Subject: Closure Packet Revision for Aniwa Arsenic Site, BRRTS #02-59-000198

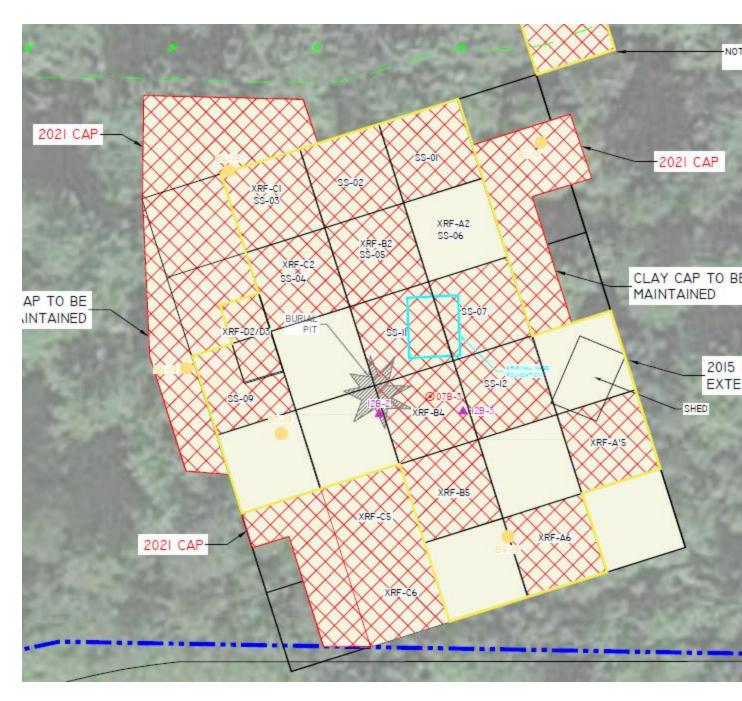
While my coworkers were reviewing the previous closure revisions and closure letter for the above-referenced site they noticed something that we believe needs to be changed on Figures B.2.b and D.2. As seen below, you have one square labeled with the sampling locations XRF-A2 and SS-06 but it isn't hatched like the other residual soil areas. Checking Table A.3 both those sampling locations are listed as having residual soil contamination so it appears the hatching may have been omitted by accident. Can you make that change on both those figures and resubmit them via email? Reach out with any questions. Thank you,
